Comments on Applicant Response to the NMFS

US Army Corps of Engineers Permit Application Number SAJ-2004-12518

This analysis was performed on behalf of the Coral Bay Community Council and Save Coral Bay Inc., both non-profit corporations.

Prepared by David L Silverman
3-22-2020

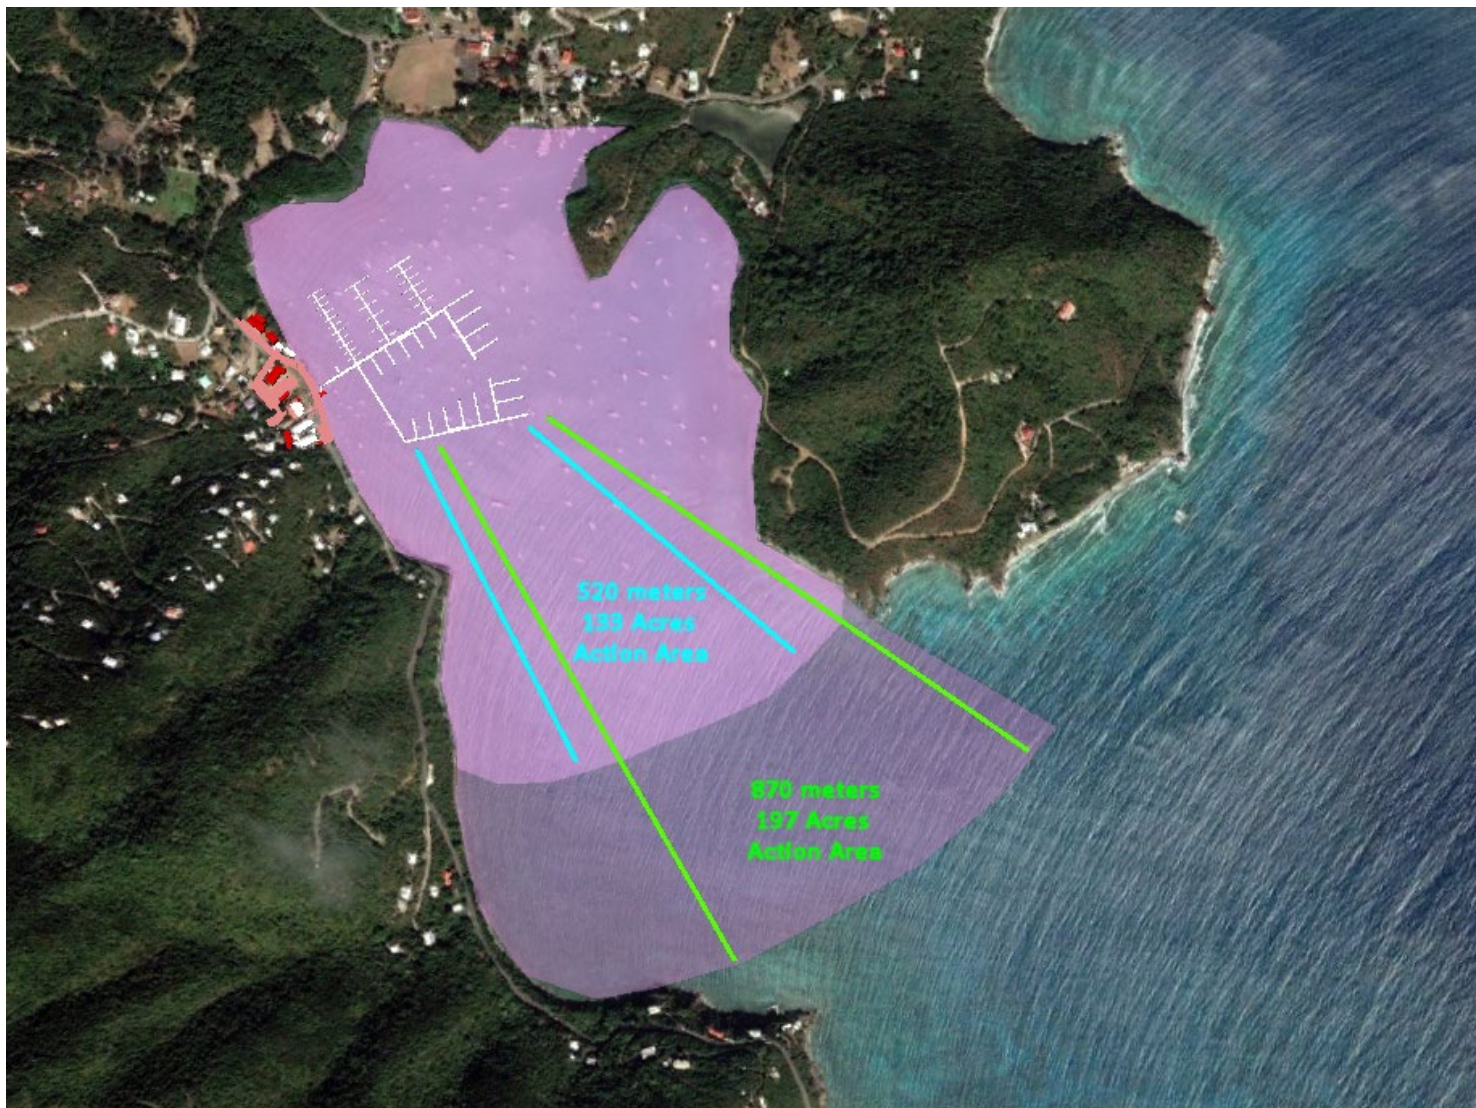
Based on this analysis we conclude that the “Action Area” extends a distance of 870 meters from the marina docks. Even if the lower velocity of 0.06 m/s is used, the Action Area would extend 522 meters from the marina docks. The Action Area based on the use of best scientific data in the calculations is shown in the graphic below:

The "Action Area" corresponding to the 0.1 m/s current velocity encompasses **197 acres**. The "Action Area" corresponding to the 0.06 m/s current velocity encompasses 133 acres. We believe that due to the large depth and quantity of silt, the higher transport velocity in the upper layers of the water, and the variability of wave heights and currents over the course of a typical year, that the larger estimate of **197 acres is the most accurate and most appropriate for assessing impacts to ESA-listed resources and habitat** based on the SDI model.

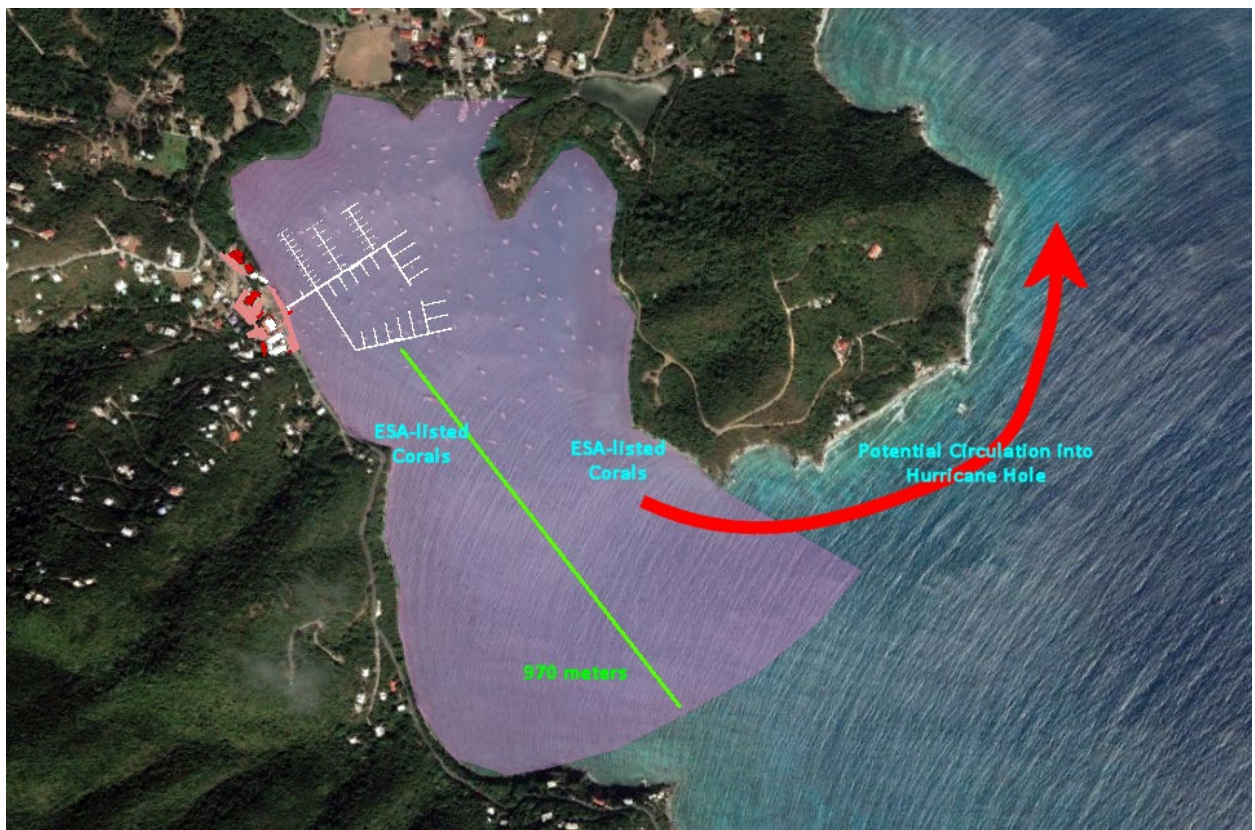
The image below shows the location of ESA-listed corals at two locations at the mouth of the harbor, as well as potential circulation pattern for suspended sediments into Hurricane Hole (Virgin Islands Coral Reef National Monument). The current flow into Hurricane Hole is discussed later.

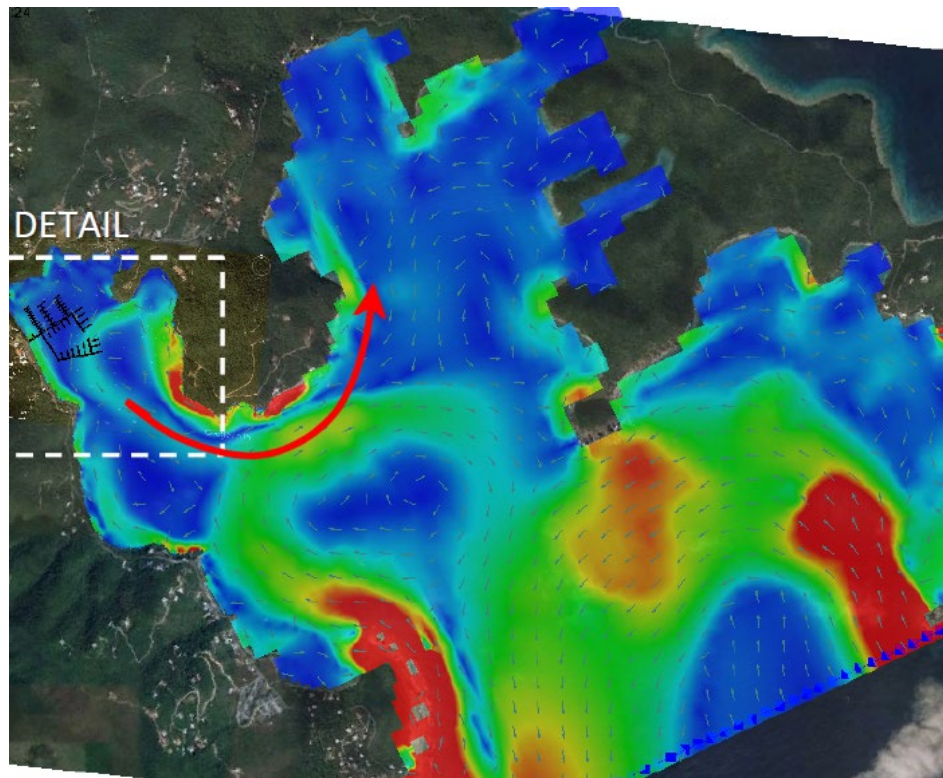
This is shown in the graphic below, taken from the Applicant's report (the green swath is modeled current in excess of 0.08 m/s and the red circle encompasses the mega yacht berths):

The band of higher current directly traversing the mega yacht berths has the potential to carry fine sediments beyond the mouth of Coral Harbor, where they are susceptible to being carried into Hurricane Hole, within the Virgin Islands Coral Reef National Monument. The red arrow in the diagram below shows this transport route based on the current modeling done by the applicant.

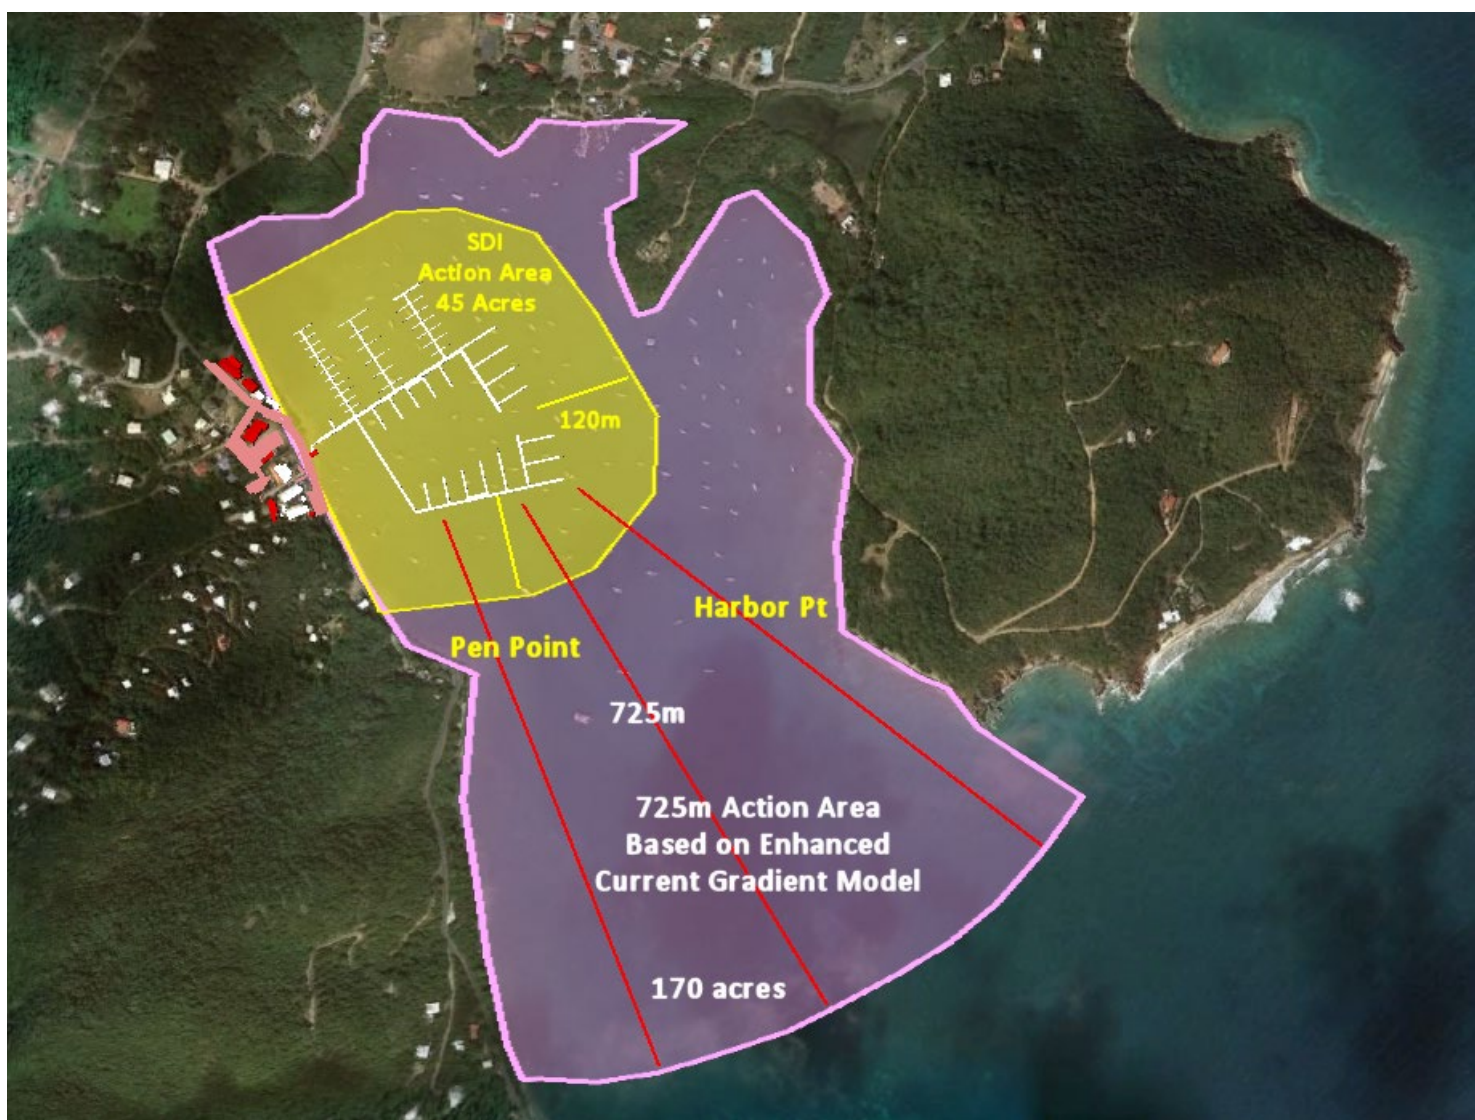
The Action Area corresponding to the transport distance for medium silt in the enhanced current gradient model is 170 acres. It extends outside the mouth of Coral Harbor, and includes both Pen Point and Harbor Point, as well as coral colonized hardbottom off of the southern end of the Fortsberg peninsula. This Action Area will also transport sediments into Hurricane Hole due to the circulation currents discussed earlier.

Therefore our best estimate of the Action Area for the Applicant's proposed project, based on the current gradient model, is as shown in the diagram below. **The transport distance to a depth of 2m for the Medium Silt component of Coral Harbor sediments will be 725 meters, corresponding to an Action Area of 170 acres.** For comparison the Action Area defined in the SDI report (120m and 45 acres) is shown overlaid in yellow:

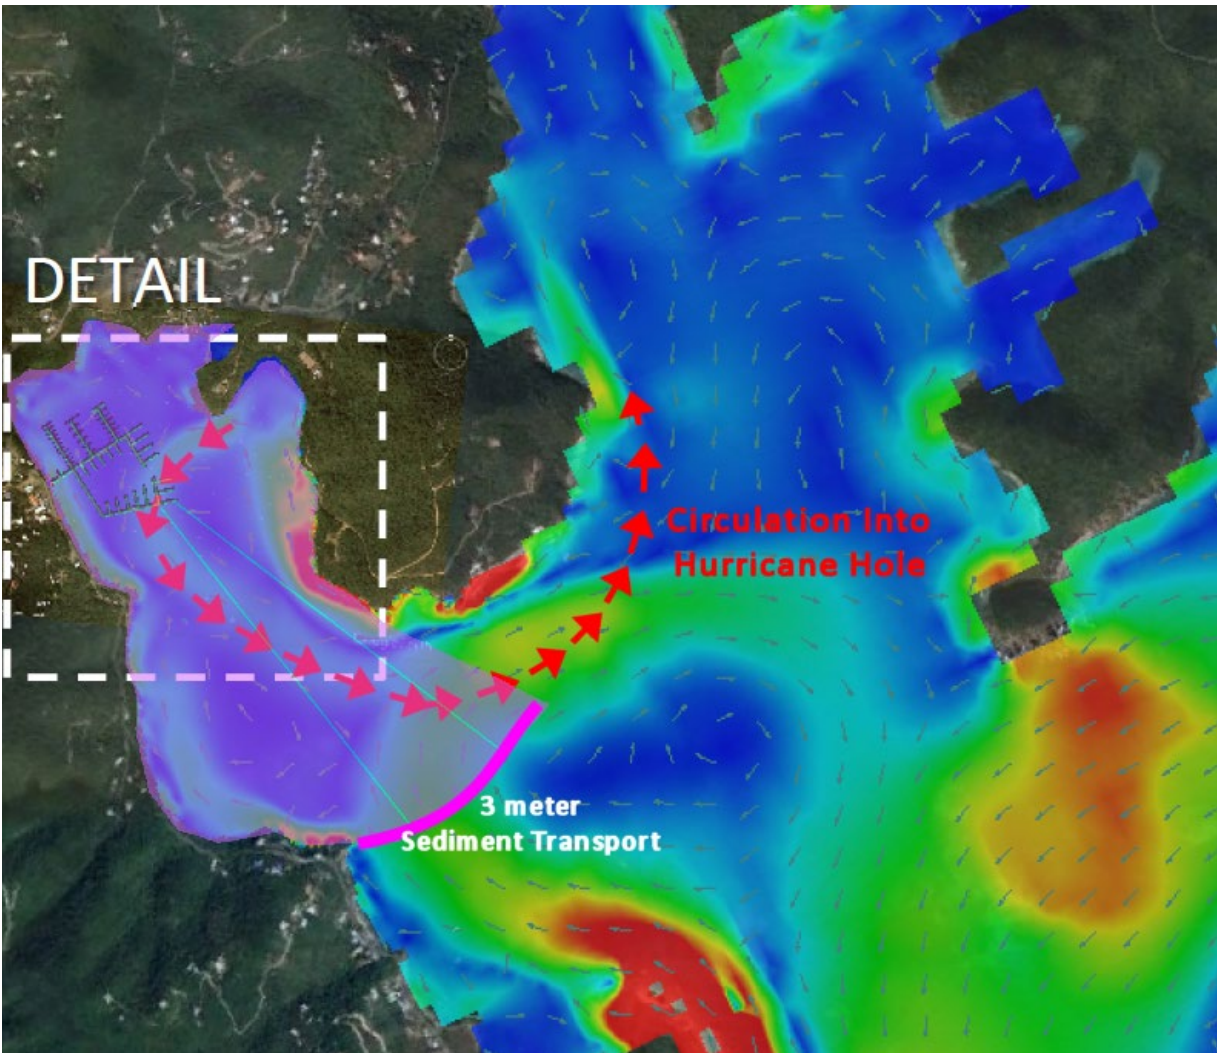
When the enhanced current gradient model is run for sediment transport to a depth of 3 meters, the interaction with circulating currents into Hurricane Hole becomes apparent. At 3 meters the sediments are transported approximately 1020 meters. Water depths at the entrance to Coral Harbor are well in excess of 3 meters, so any sediments transported that distance will be caught in circulating currents as illustrated below:

The potential for impact to ESA-listed resources within Hurricane Hole is a matter of great concern, as evidenced by the testimony in 2015 of Park Superintendent Brion Fitzgerald and Dr. Caroline Rogers. In order to quantify this risk a far more detailed study of circulating current patterns needs to be performed, including calibration under a range of wind and sea conditions, throughout the year. Additionally, quantitative studies of the volume of fine sediments within the marina footprint need to be undertaken, and calibrated models of propeller wash and seabed scouring from mega yacht activity need to be factored into the analysis.

Bird's Eye View Of Renovated Retail Area

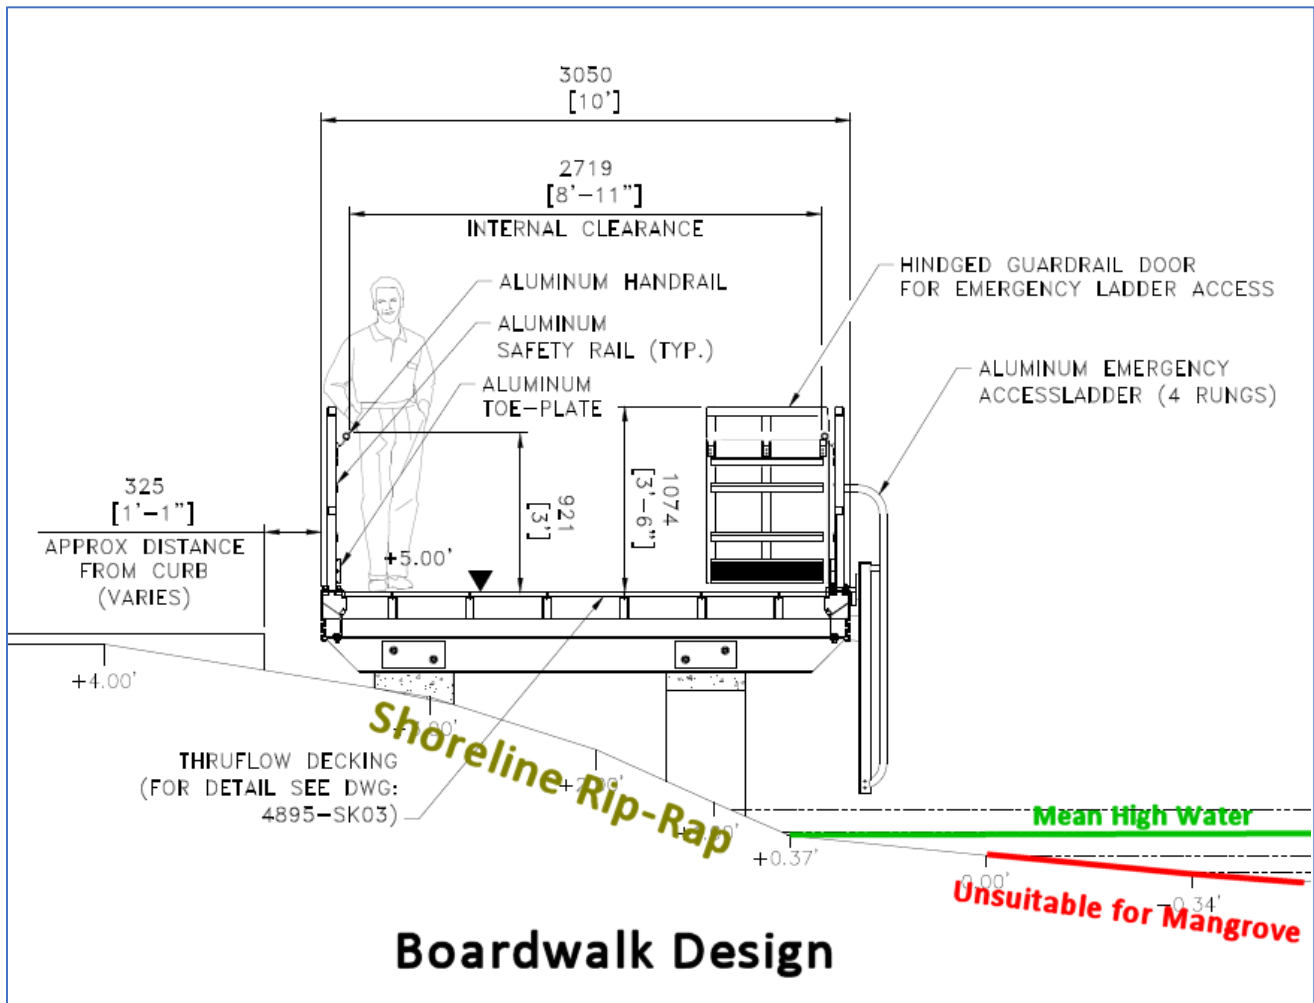
Furthermore, in their latest plans, the Applicant has proposed a boardwalk in the precise location where the mangroves had previously been proposed (the rip-rap revetment). Their most recent rendering shows a neat hedge of mangroves on the water side of the boardwalk, which is clearly not a feasible plan for mangrove planting due to water depth and exposure:

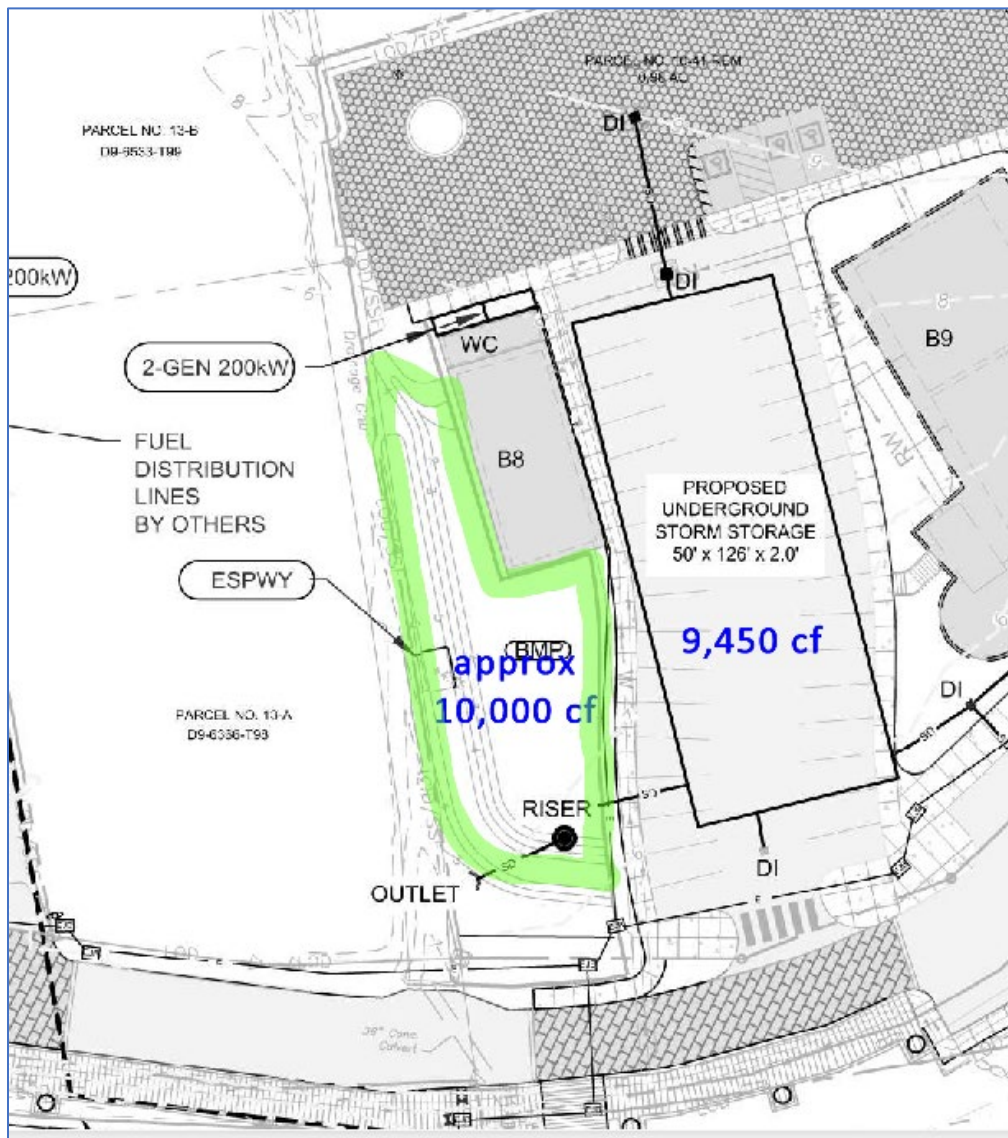
The components of the new stormwater design are shown in the illustration below. This plan has never been accompanied by engineering calculations or environmental assessment. It provides about one third of the detention capacity as the prior, engineered plan. There is no document describing how storm water flows that are not traversing the Applicant's property will be diverted off the adjacent parcel.

Based on new construction that has taken place since 2016, we do not see any way the "revised" stormwater plan can be successful.
